APPLICATION FOR PERMIT

**CITY OF PORTLAND, MAINE
SITE PLAN REVIEW
Processing Form**

BUILDING PERMIT REPORT

November 10, 1986

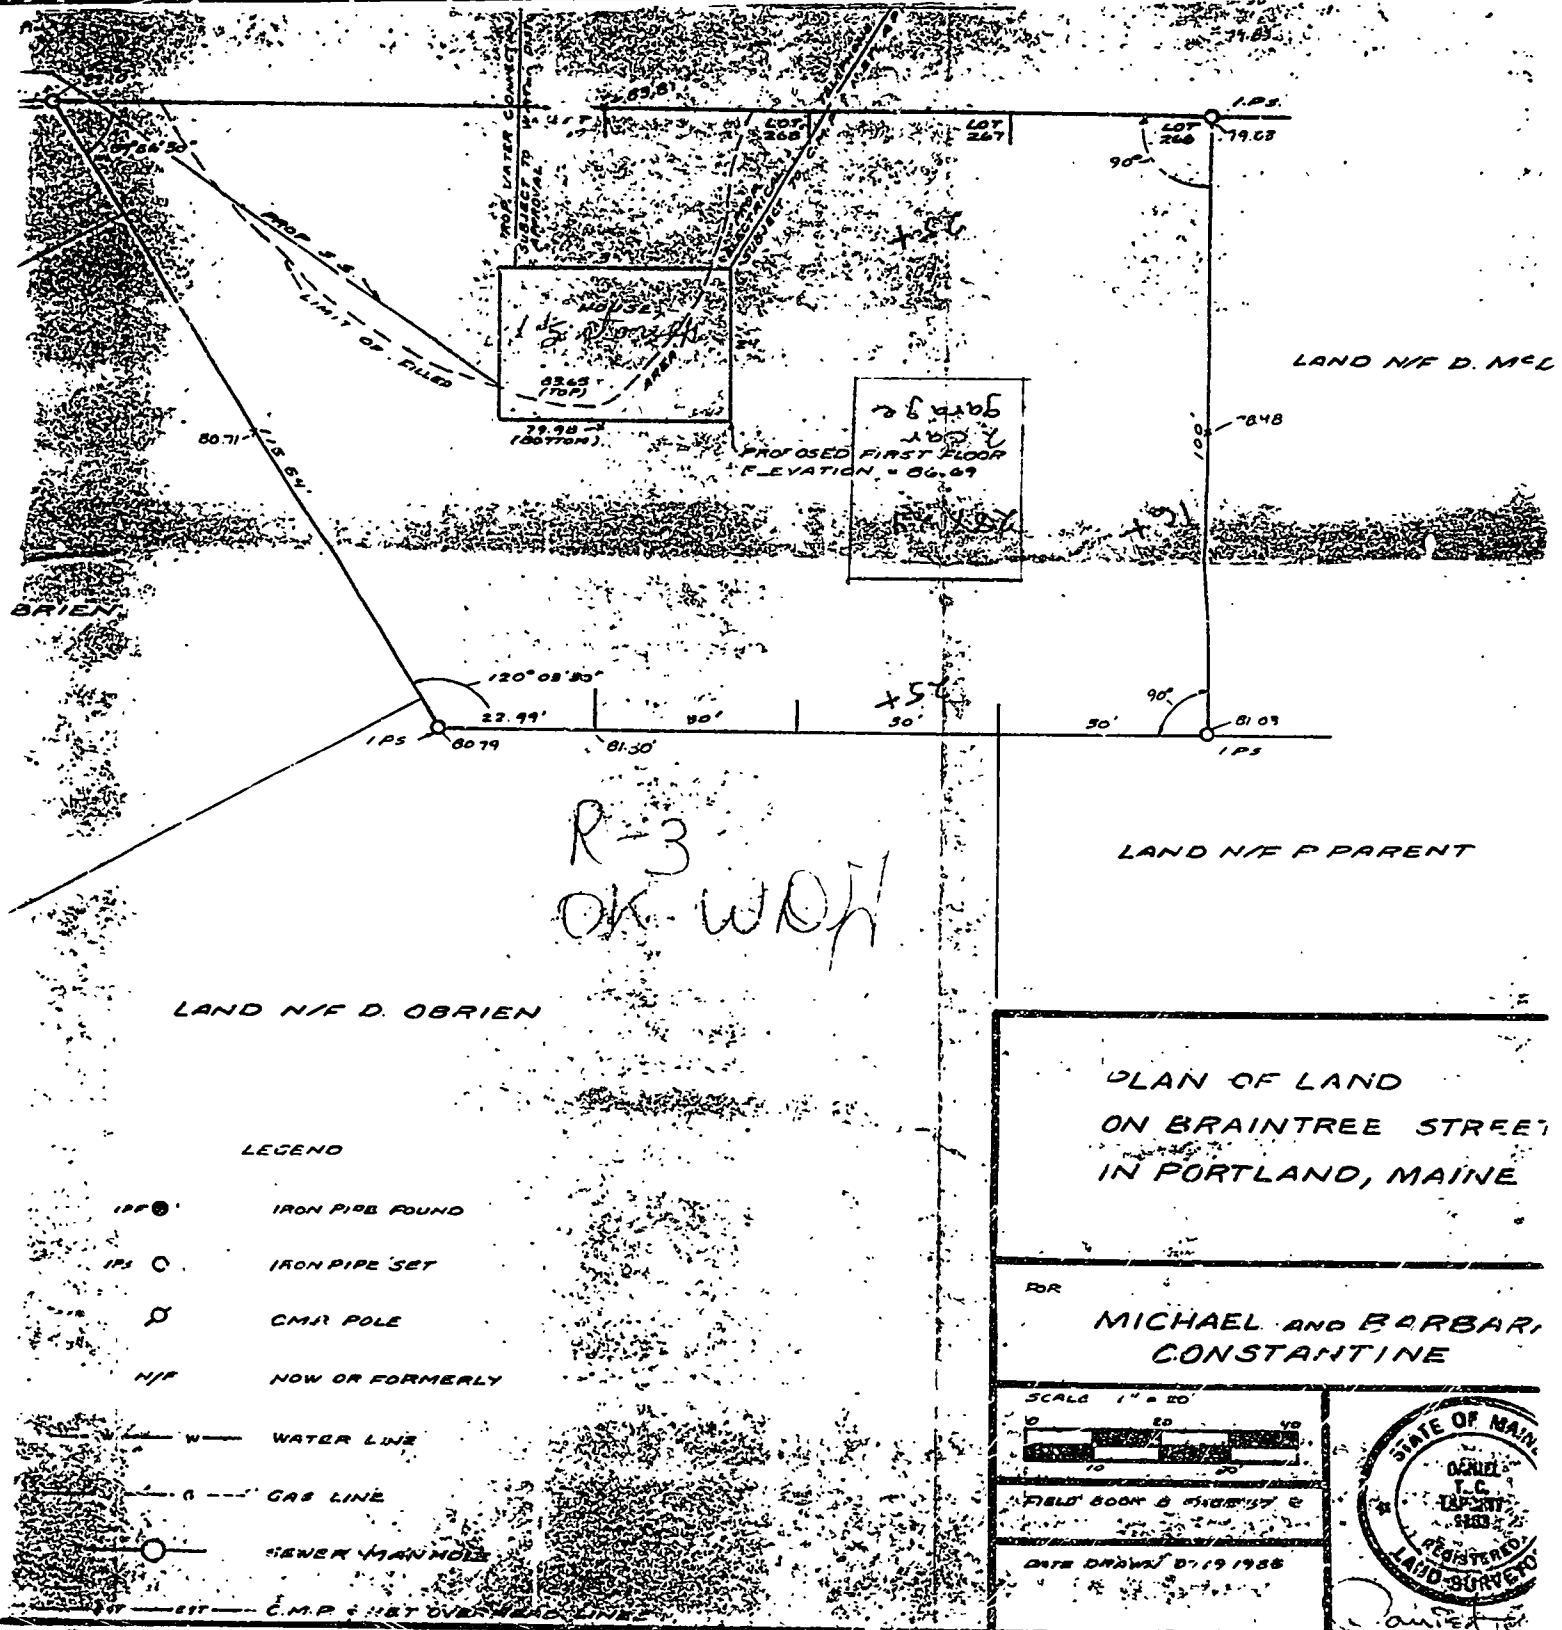
REASONS: 1) First floor elevation of the proposed building shall be indicated on the plan.
 2) No street opening or sewer connection permit will be issued after Nov. 15th

26400' AREA
GARAGE
PROPOSED FIRST FLOOR
ELEVATION = 81.69
